3809
(UT-050)
UTU-79909

RE: Review of Proposed Operations; Notice Incomplete

Sandy Nell Prospect, Applicant's Proposed Sites--08/11/03

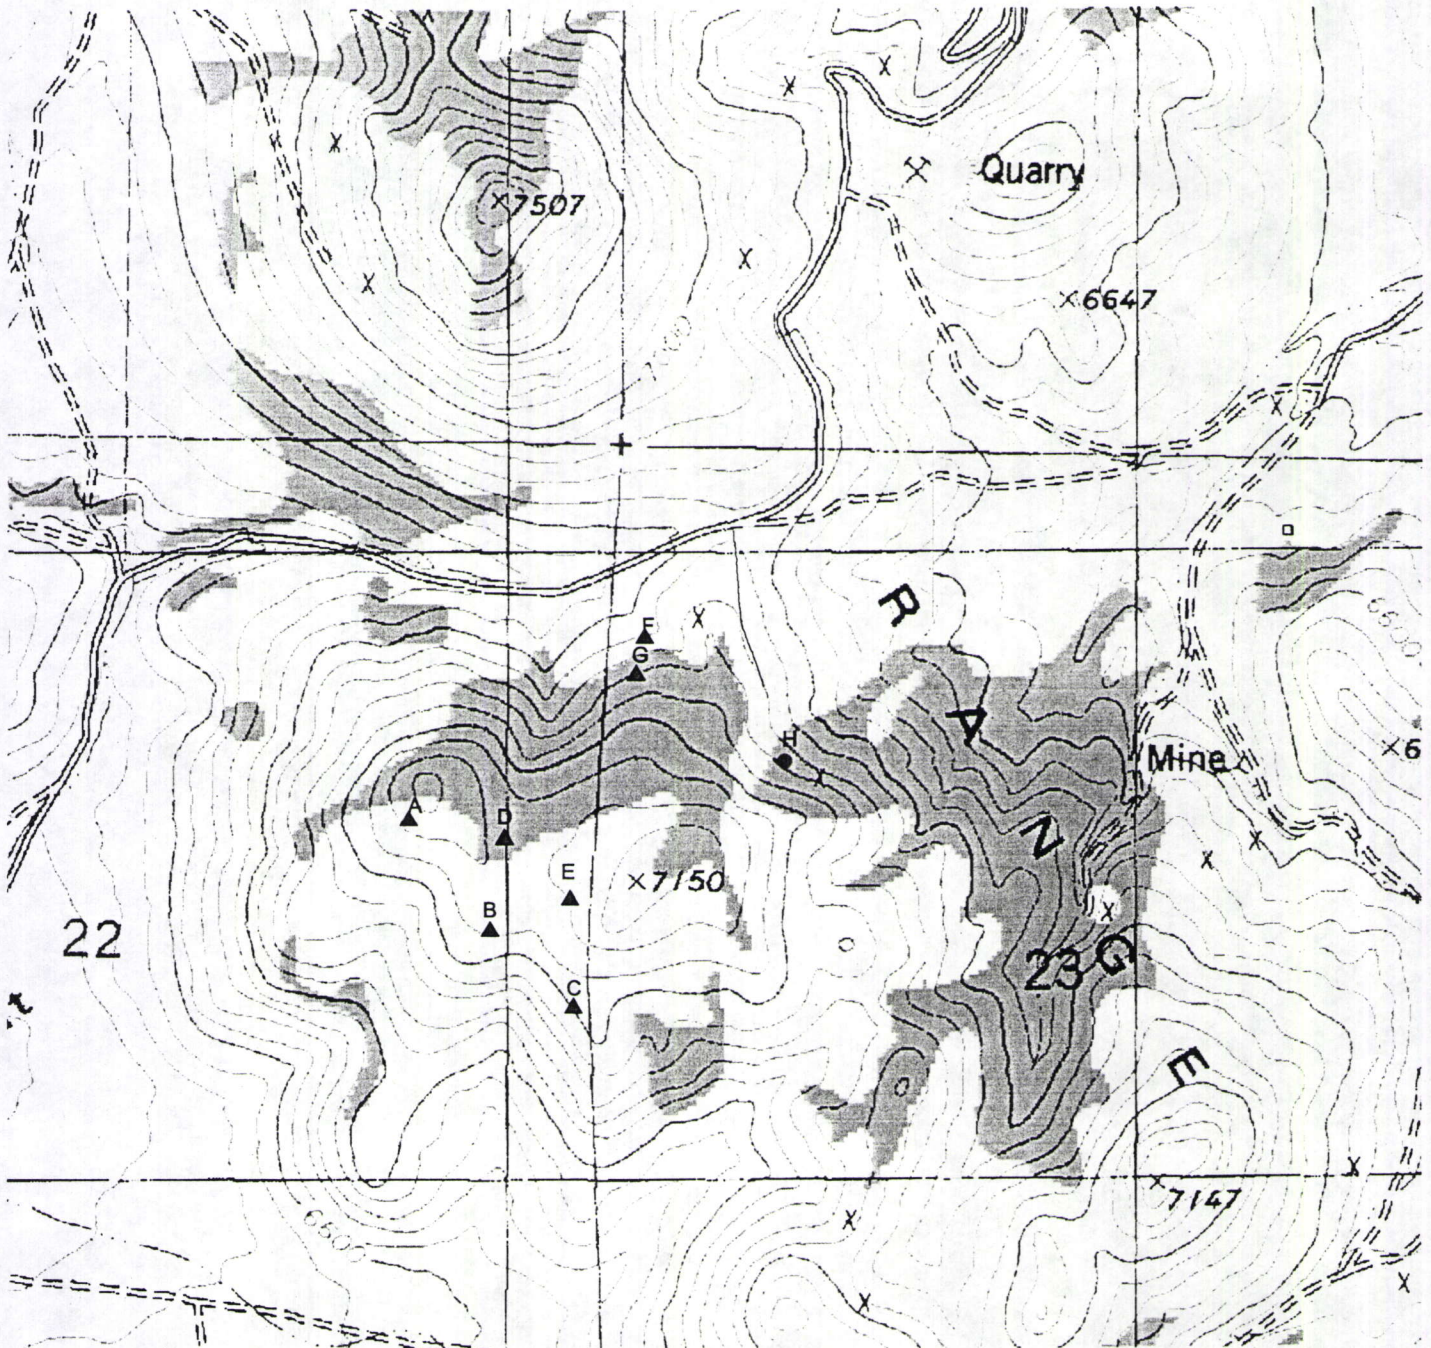
Based on your map, our understanding apparently was not consistent with your proposal as submitted to this office on August 11, 2003. You have proposed eight drill sites rather than four to five. In addition, the drill sites as shown on your map are not consistent with our understanding of the general location of your project area. That discrepancy may be due to the scale of the map that you have used. To assist you, we have prepared an ArcView map that shows the location of the proposed drill holes, based on the GPS survey and your map showing locations of drill sites.

If you examine the second ArcView map (Sandy Nell Prospect, Applicant's Proposed Drill Sites—

08/11/03), drill hole sites F and G may be the ones that in the field you had proposed as being on the access road, north of the switchback. Drill hole sites A-E may be the ones that we understood to be in a saddle, south of the working shown as an X on the map and north of the topographic high of 7150 feet elevation. Drill hole H is the location of that proposed site as surveyed by GPS, which differs somewhat from your map. Further, drill holes A-E are described as being approximately 100 feet apart, but based on the ArcView map, are 500 to 600 feet apart. In addition, at these sites, directional holes are only described in your letter at site H, whereas, we had understood that directional holes would be drilled at sites F and G, as well.

In order to complete your filing for a notice, please address the above, described discrepancies in the locations of the proposed drill holes, and address the items related to exploration drilling in our earlier letter. We have enclosed a third ArcView map for your convenience that does not show any drill hole sites.

We recommend that you flag the locations on the ground, and we could GPS those sites and provide you with a map. We will be willing to meet with you in the field or in this office to answer any questions or to assist you in completing your filing.
